**THE NETWORK RAIL (OLD OAK COMMON GREAT WESTERN MAINLINE
TRACK ACCESS) ORDER**

PROOF OF EVIDENCE

CHRISTOPHER ALAN GENT MEng CEng MCIHT MICE

SUBMITTED ON BEHALF OF BELLAVIEW PROPERTIES LTD

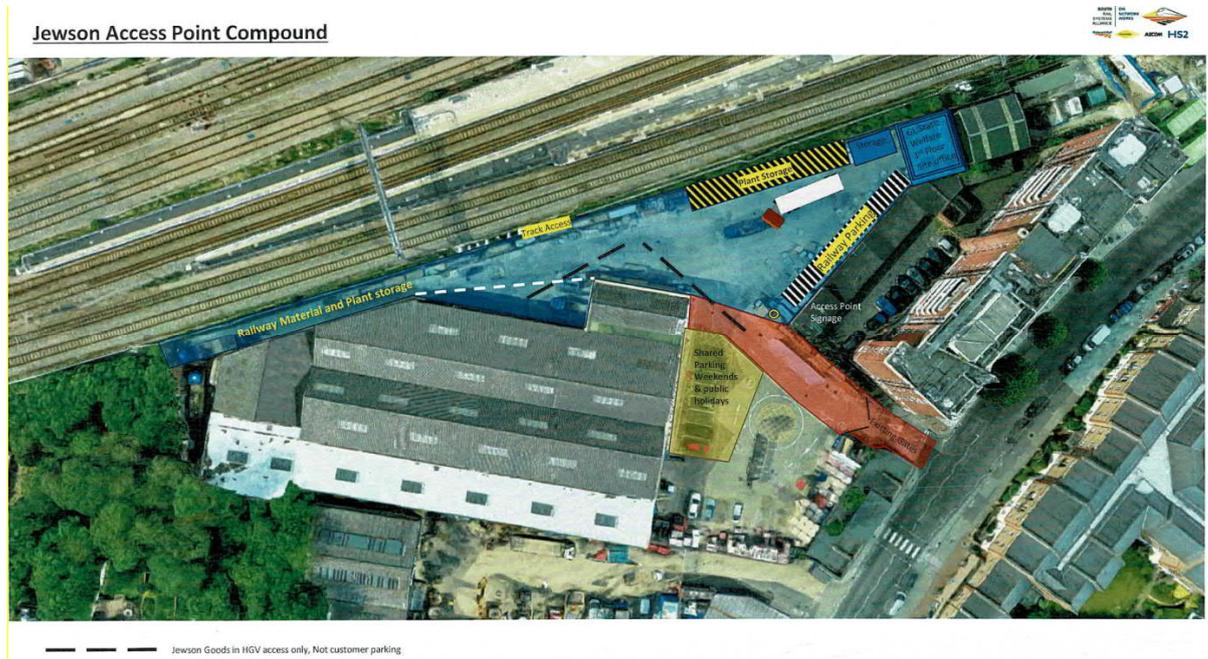
proposed redevelopment building footprint would extend closer to the railway. NR had taken account of these constraints and produced a revised compound drawing (issued to me and the BPL team on site), removing the two storage areas conflicting with the existing Jewson's access and the proposed redevelopment building line, and annotating the plan to confirm Jewson's shared access within the NR compound area. This revised layout plan is reproduced below and provided at **Appendix D**

- 3.9 The first important point to note is that the “vital” and “key” requirements (identified to be provided by the current warehouse building and used, at least in part, to justify the original site selection) no longer form part of the requirements currently being advised to BPL and its consultants.

- 3.10 The second important point to note is that the original consultation description in my view infers continuous use of the site “will be operational 24 hours a day”, whereas NR’s current requirement as explained to me on site is broadly “overnight, once a fortnight”, which even at 24 hours once a fortnight means the site would not be in use by NR 13/14 or 93% of the time.

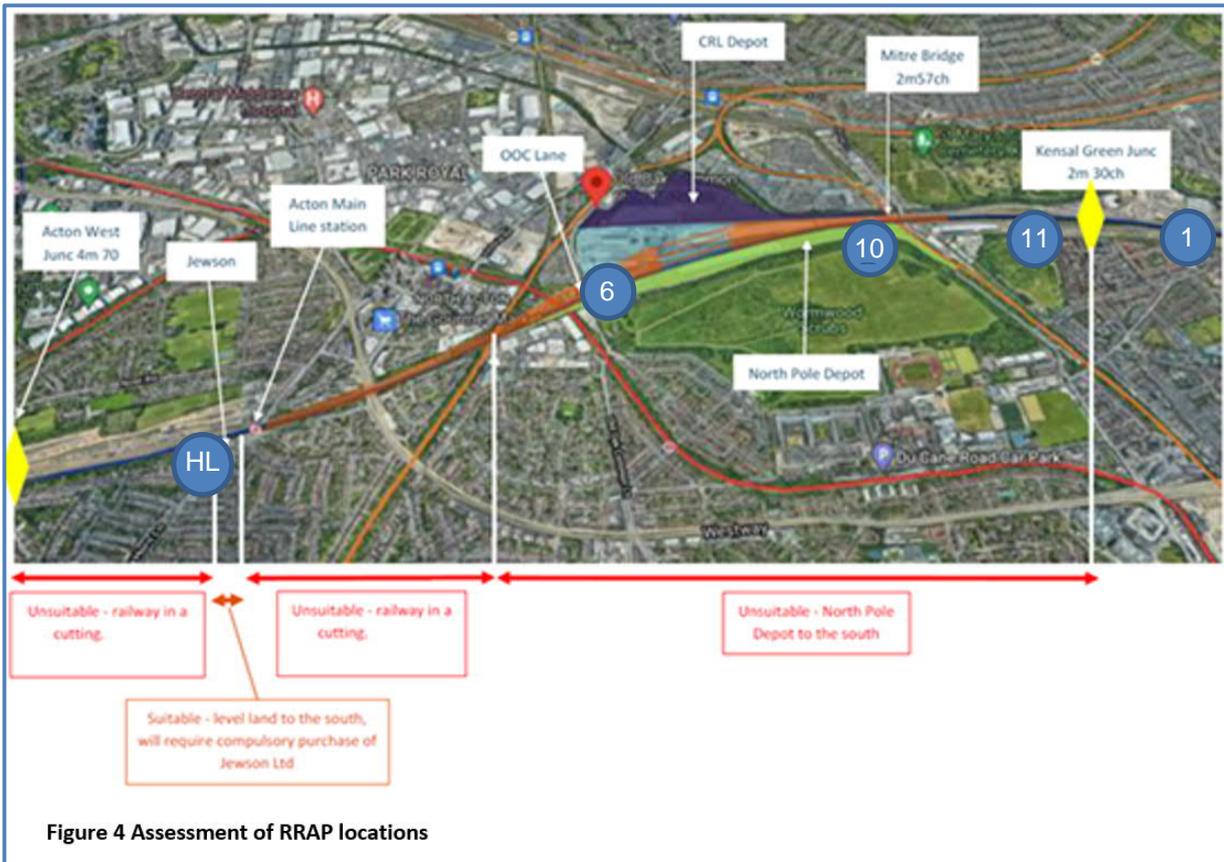
- 10) West of Mitre Bridge; and
 - 11) West of the Engine and Carriage Line Bridge.
- 3.18 Figure 4 in the SoA **[CD/03]** shows the geographical locations between Acton West Junction and Kensal Green Junction (where access to the railway is required). I have reproduced Figure 4 of the SoA, below, and annotated it with the relevant references to six of the potential access points.

- 3.19 I have excluded 2, 3, and 7 (as referred to above) as I understand they are too remote from the area of access; I have excluded 4, because it no longer exists (and has not existed since it was

removed to enable the Elizabeth Line station works in 2019); I have excluded 5 as it is plainly not a realistic option due to the 6m level difference; and I have excluded 8 as it provides access to the relief lines not the main lines. Bloomsbury Close “9”, is located just off the plan to the west and is shown deliberately in the margin of the plan. 239 Horn Lane is referred to as “HL”.

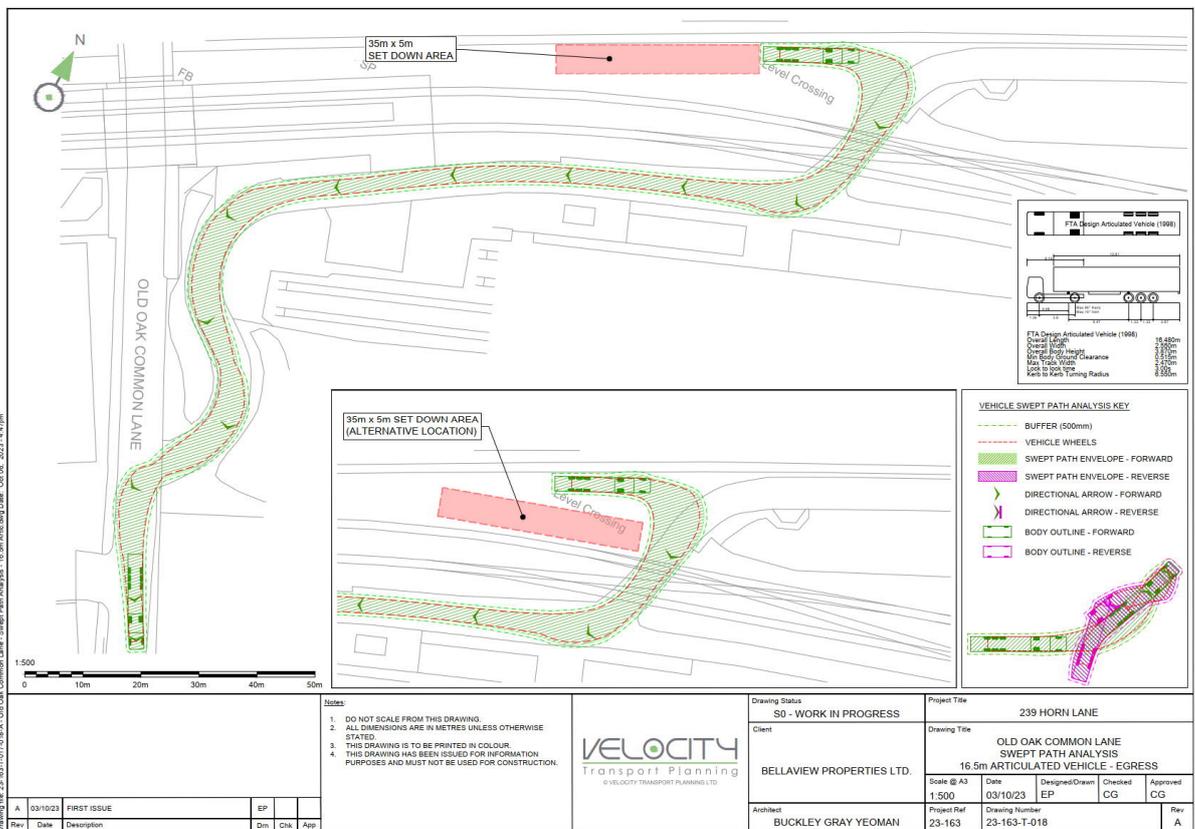
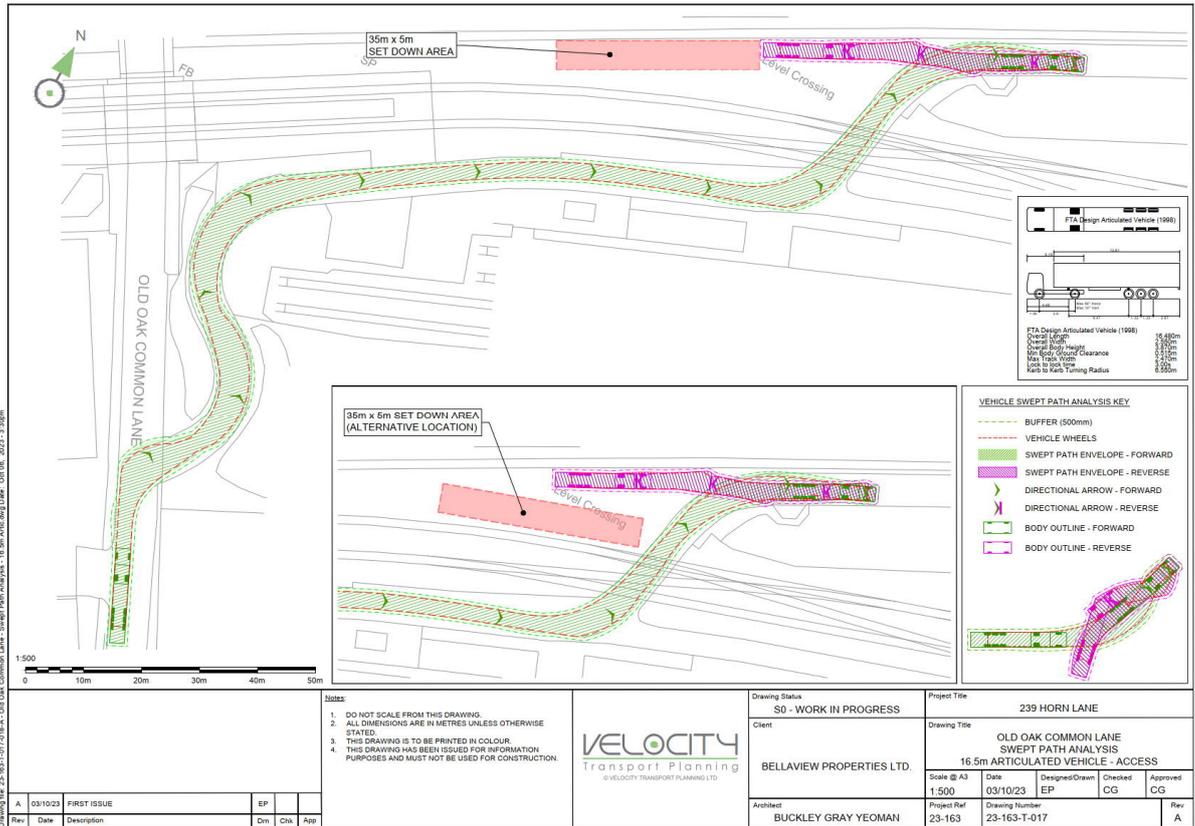
3.25 The GRIP 4 Construction Methodology Report (152270-ARC-REP-EMF-000005) **[Appendix F]** identifies at Paragraphs 4.1.3.9 – 4.1.3.11 that this location **is proposed** [my emphasis] as the South West RRAP. It identifies an access route via Mitre Way and indicates that vehicle tracking (swept path analysis) has been undertaken (although this is not shown). The proposed route (Figure 9) is reproduced below:

- 3.26 Figure 30 of the GRIP 4 report identifies that there is a 4.25m vehicular height restriction via Mitre Way, a 3.8m restriction via Old Oak Common Lane (north) and a 4.8m restriction via Old Oak Common Lane (south). Both the route via Mitre Way and Old Oak Common Lane (south) would be accessible to typical vehicles expected to access the site (up to 4m high, as identified in paragraph 5.3.6.2 of the GRIP 4 report). The height restriction on the route to the north along Old Oak Common Lane would prevent taller vehicles using this route, although a) access is more likely to be from the south (the A406 North Circular Road) and b) paragraph 5.3.6.4 of the GRIP4 report notes that the road will be lowered and the bridges replaced as part of the major civils works on the project, providing the “opportunity for larger vehicles to utilise this route as the programme develops”.

- 3.29 I have assessed the potential access arrangements from Old Oak Common Lane using industry standard swept path analysis software to determine whether there is a restriction on access from Old Oak Common Lane. I have tested the access route using the FTA Design Articulated Vehicle (1998), Width 2550, Length 16480, W/W Rad 7314, as used by NR in its own swept path analyses of access to 239 Horn Lane (as shown on the Deemed Planning Drawing **[CD/11.2]**). This demonstrates that the vehicle can access and egress a set down area 5m wide by 35m long as shown in my drawings 23-163-T017 and 23-163-T018 **[Appendix H]** reproduced below.

3.30 The drawings show that access and egress is achievable within the envelope of the available carriageway.

3.31 The route appears to be in use currently as an emergency egress only, and is not wide enough to allow two vehicles to pass in opposite directions. Consequently, alternate way working and access and egress to Old Oak Common Lane would need to be managed under the control of qualified traffic marshals (i.e. stopping traffic in both directions on Old Oak Common Lane for a short period to allow a vehicle to enter or exit, and managing the arrivals and departures of vehicles so that they do not overlap). This approach is no different to the accepted control measures at many construction sites in London.

- 1) The current road layout would prevent direct access from Old Oak Common Lane to a RRAP in this location.
- 2) Old Oak Common Lane would need to be closed (other than for temporary stopping of traffic movements under traffic marshal control – typically 1-2 minutes 16 times per fortnightly possession). The route from Mitre Way is also an option, as identified in the GRIP 4 report, although I will leave it to the evidence of Mr Nick Gallop to discuss any protocols for managing joint access with the depot operator.
- 3) A set down area of 35m x 5m appears to be readily achievable adjacent to the RRAP.

Figure 19: Temporary Stage of Jewson Acton SW RRAP

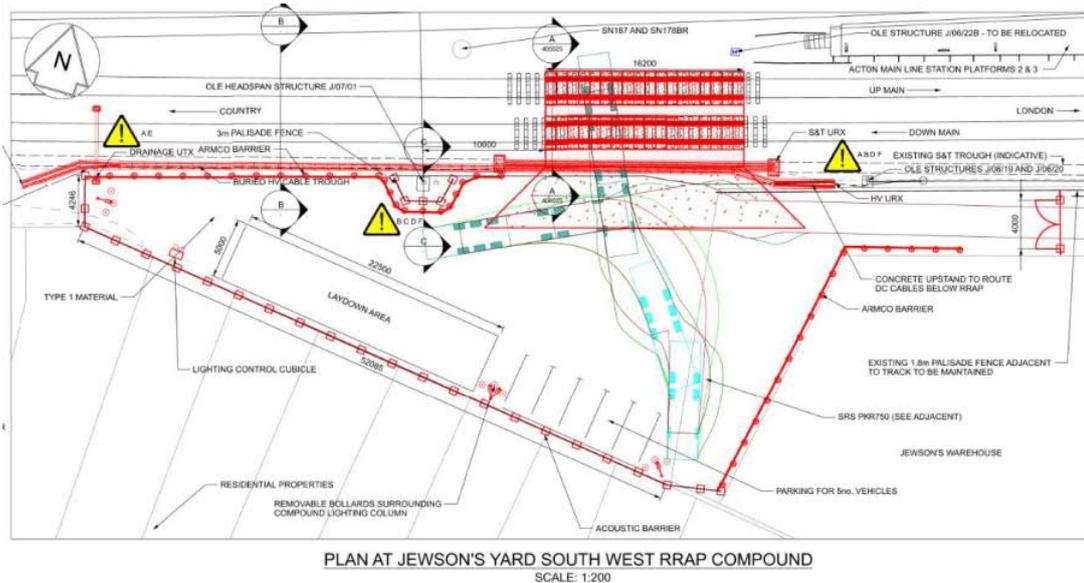
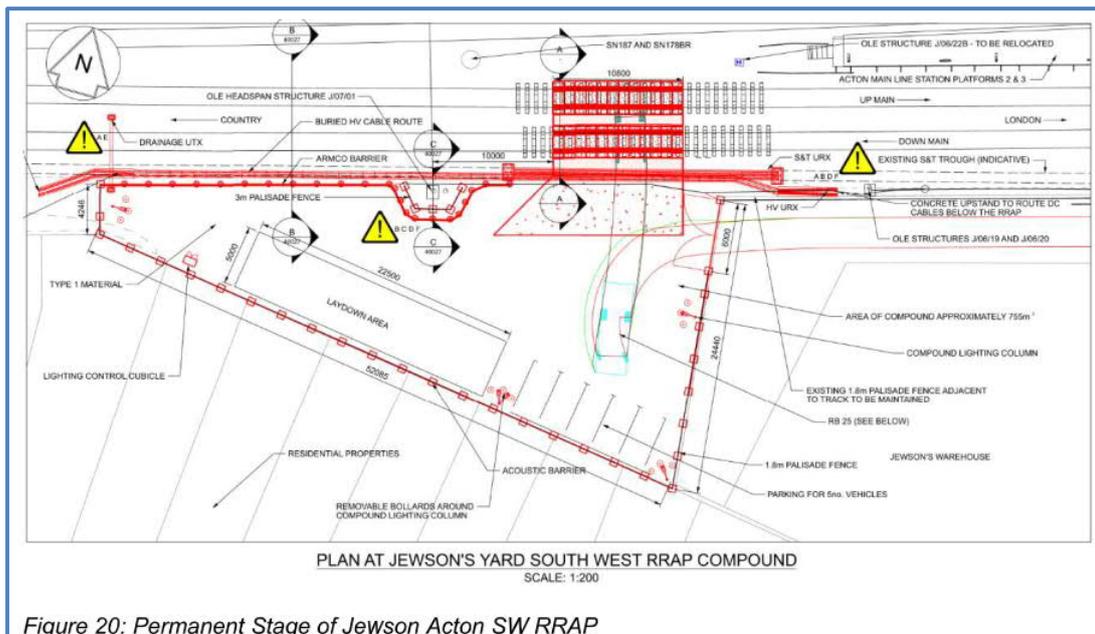
4.16 I note that the proposed temporary and permanent designs shown respectively in Figures 19 and 20 of the Construction Methodology Report (152270-ARC-REP-EMF-000005-P05) **[Appendix D]**, reproduced below, showed the temporary RRAP location in broadly the same location as the permanent RRAP.

- 4.17 I also note that based on the topographical survey information I have seen, and my own on site observations, there is little to no difference in height between the Triangle Site and the top of rails, with perhaps the Triangle Site needing to be raised up a little.

- 4.18 Given the apparent technical challenges with levels, drainage and access associated with the proposed temporary RRAP in the centre of the 239 Horn Lane railway frontage (and notwithstanding my earlier observations in relation to Matter 2 that there are other sites on operational railway land that should be considered more thoroughly before any compulsory purchase of 239 Horn Lane should be permitted), it would seem sensible to revisit the possibility of locating both the temporary and permanent RRAP locations within the Triangle Site.

- 4.19 As far as I have seen within the documentation, NR has not provided an explanation as to why this option was discontinued from consideration and the decision was made to pursue the temporary RRAP from within the 239 Horn Lane site.
